Stolle Machinery Company, LLC

Technical Bulletin Number: 006

Necker (E-NCKR) Light Test Seal Puck Body

This bulletin applies to all Stolle Die Neckers with a Light Test Module

Figure 1-1. Light Test Damage

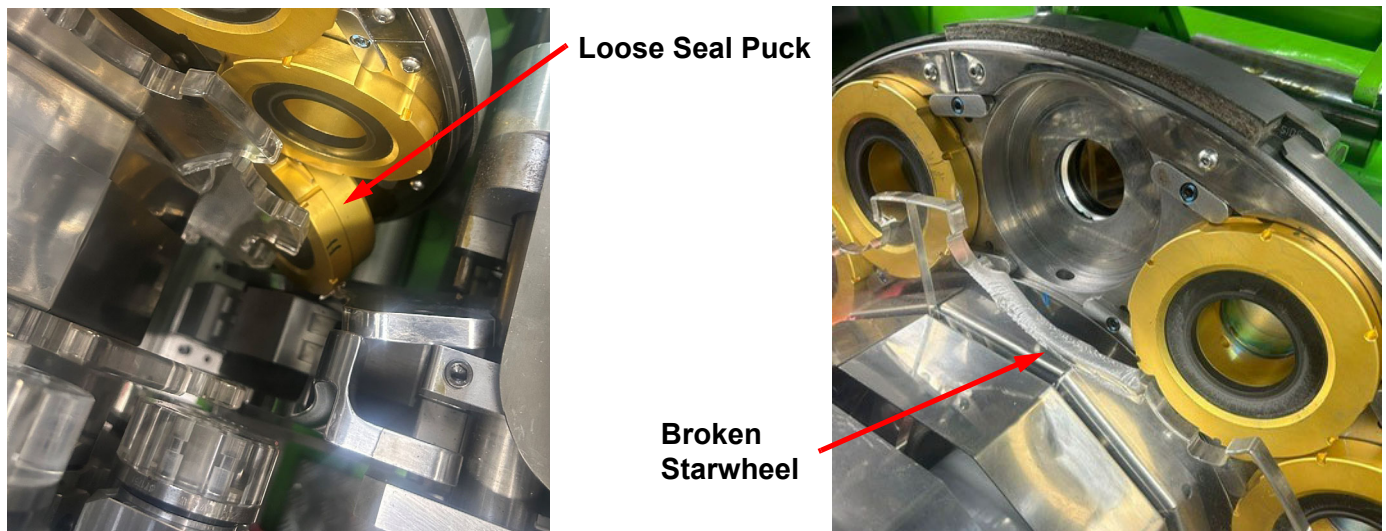
If the socket head cap screw used to fix the Seal Puck Lock Block in place is improperly installed or insufficiently tightened the Lock Block can become loose. This allows movement of the Seal Puck to the point it can fall outward into the process turret while it is in operation. The Starwheel or Guide may be seriously damaged.
